BID #709 – Ventura College STEM Program Building Improvements

ADDENDUM 001, dated 05/15/2025

DRAWING changes and clarifications noted as Addendum 01 and dated 05/15/2025:

DROP OFF AREA LIGHTING NEW WORK AND PHOTOMETRIC PLAN

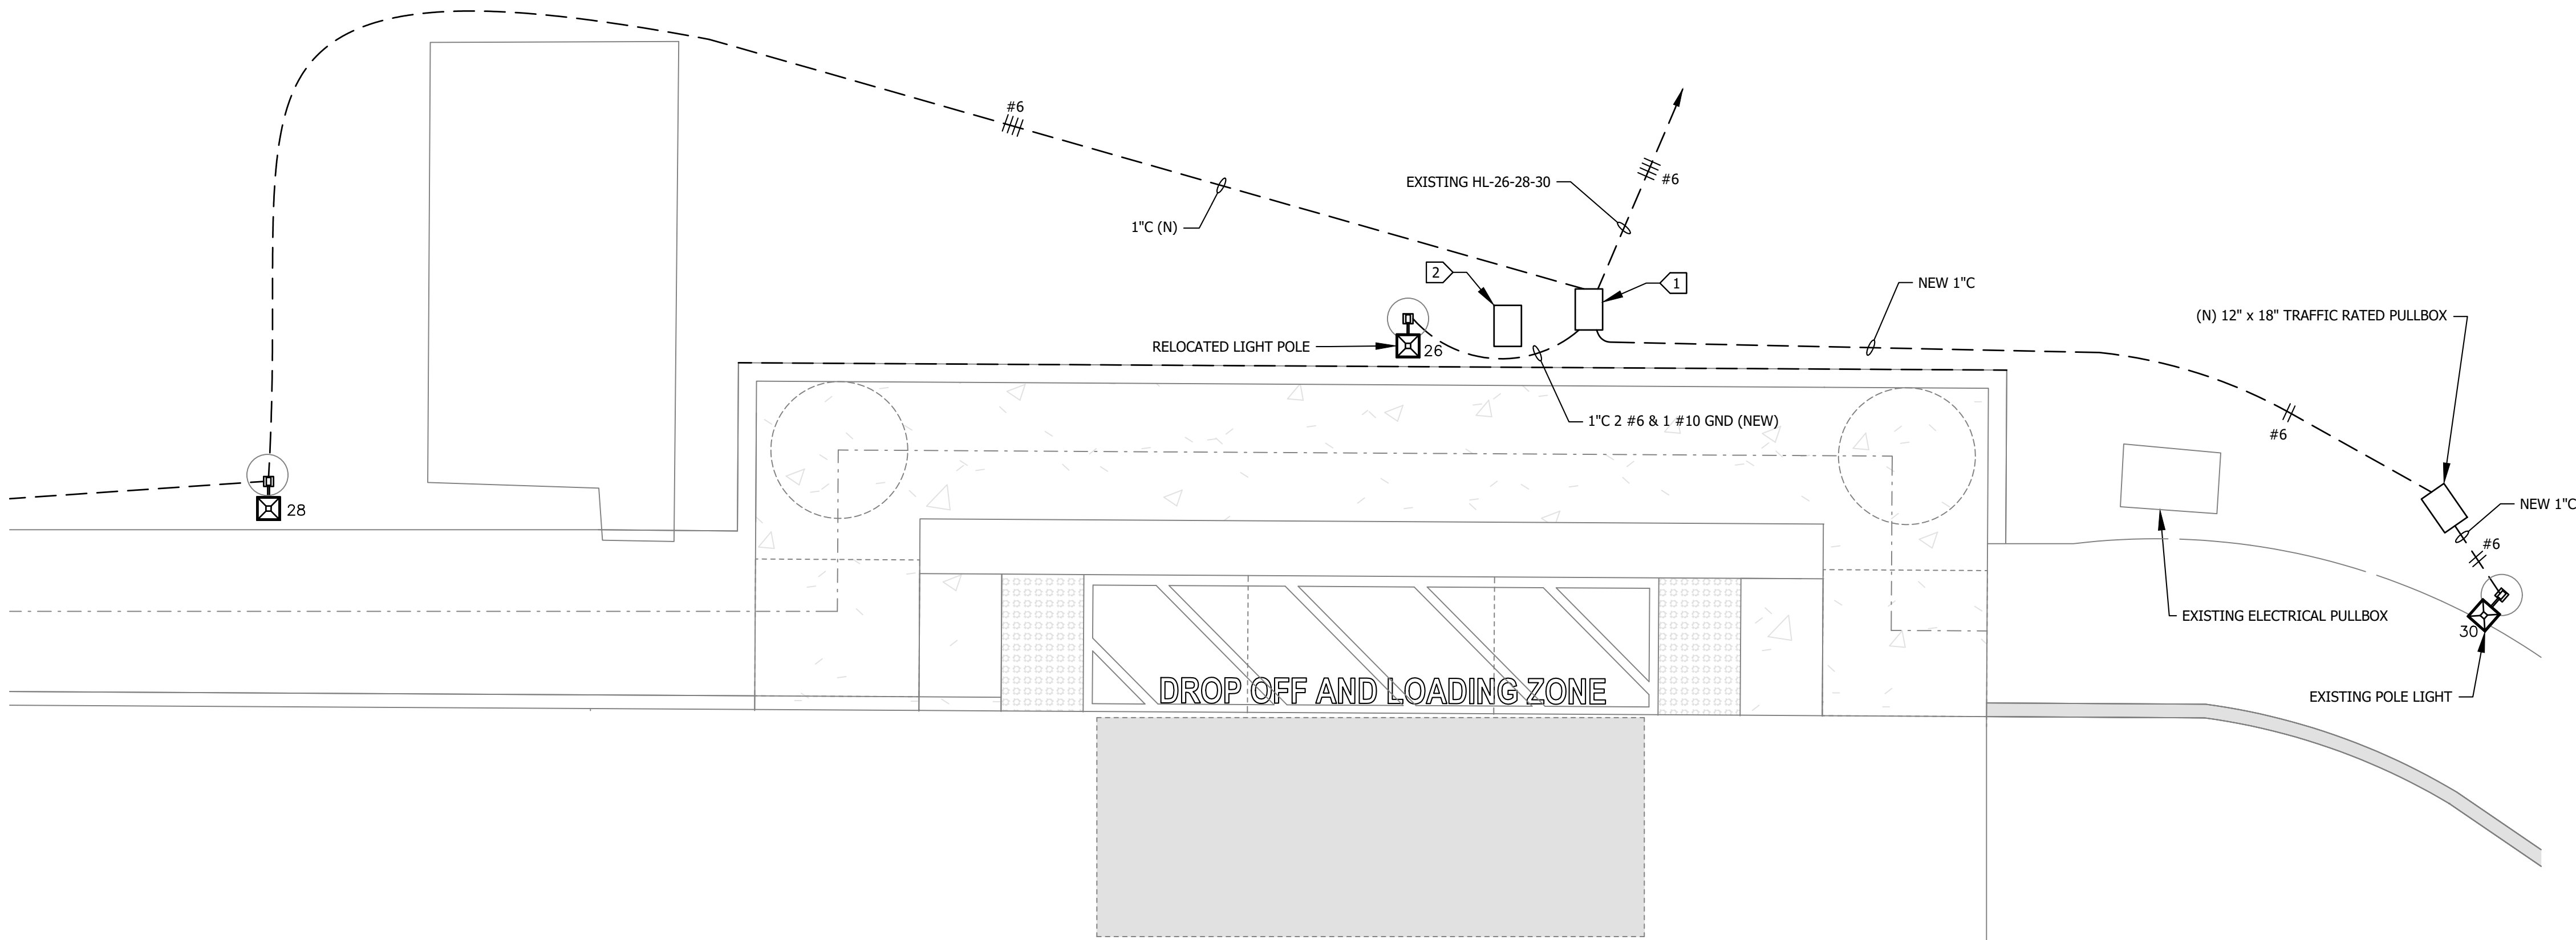
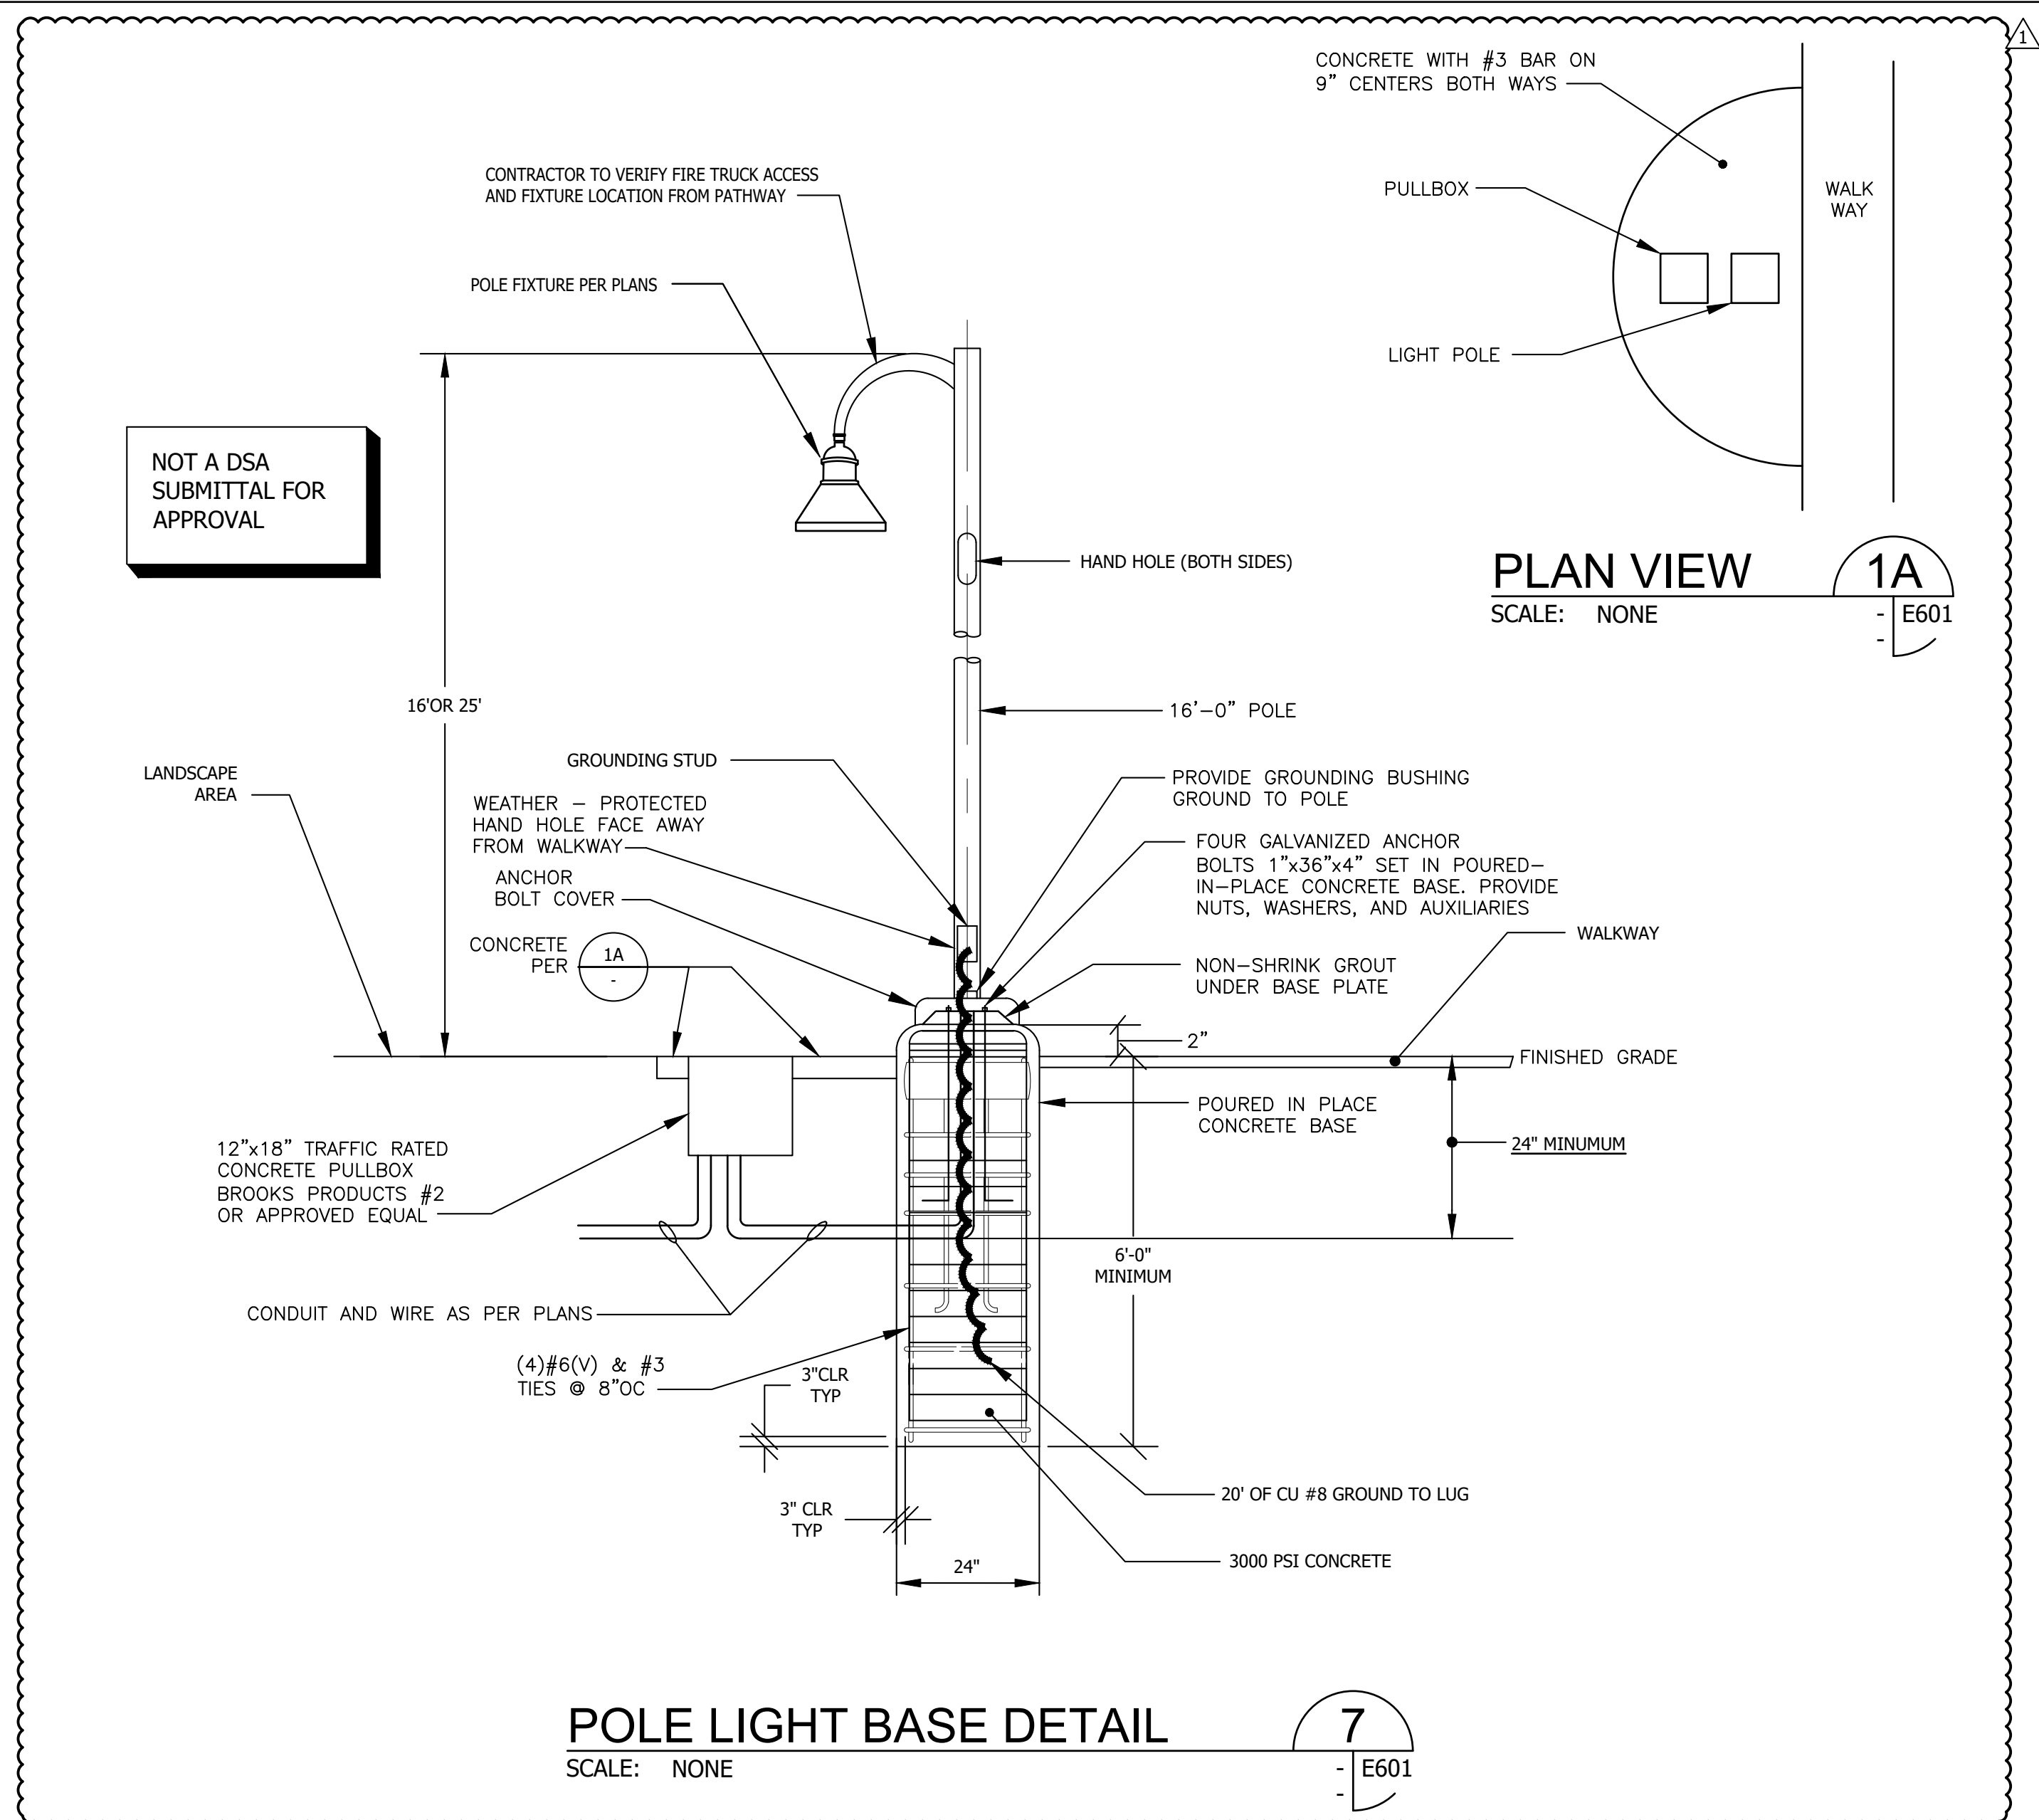
E134 – NEW DRAWING; DROP OFF AREA LIGHTING NEW WORK AND PHOTOMETRIC PLAN
